Ideal Beach Park

Bayside Parkway, North Middletown, Middletown Township NJ

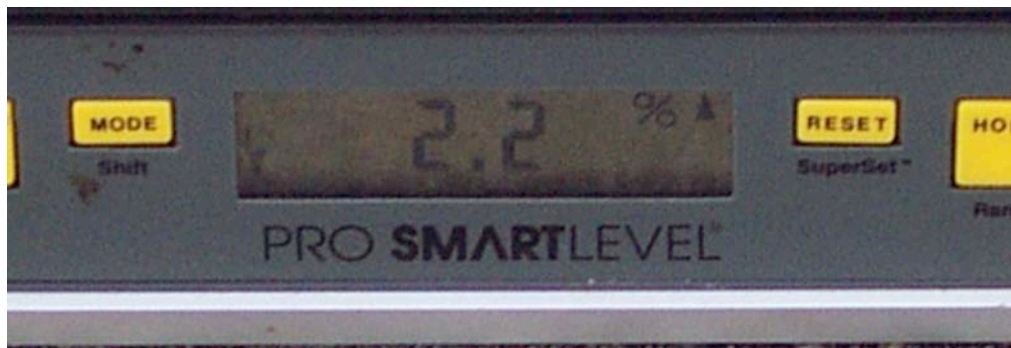
1. The parking lot has the following problems which need to be corrected.
 - a. The right parking space facing the beach has a running slope of 3.3%, contrary to ANSI section 502.4 and ADAAG section 4.6.3.

- b. The left parking space has a slope of 4.3%, contrary to ANSI section 502.4 and ADAAG section 4.6.3.
